### **Amendments to the Drawings**

### Remarks

This is responsive to the Office Action of December 30, 2005. These amendments and remarks are proper, do not introduce new matter, are not narrowing in view of a rejection over a cited reference, are clarifying in nature and serve to substantiate why the application is in proper condition for reconsideration and allowance.

FIG. 8

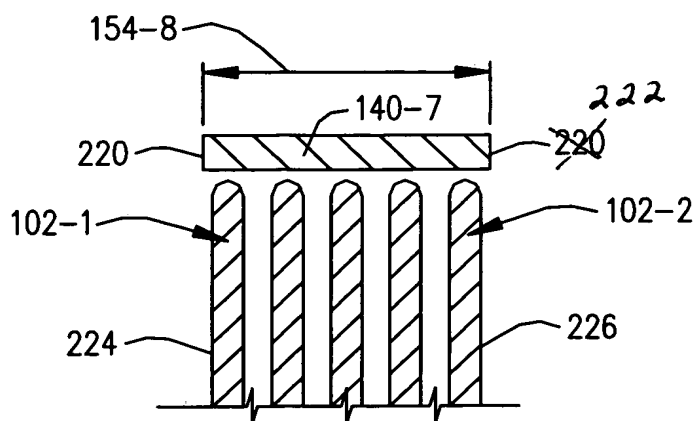
The attached sheets of drawings include amendments to FIGS. 8, 9 and 13. FIG. 8 has been amended to change one of the items 220 to item 222. FIG. 9 has been amended to change item 107-7 to item 170-7. FIG. 13 has been amended to change “RETRACK” to “RETRACT” in block 258.
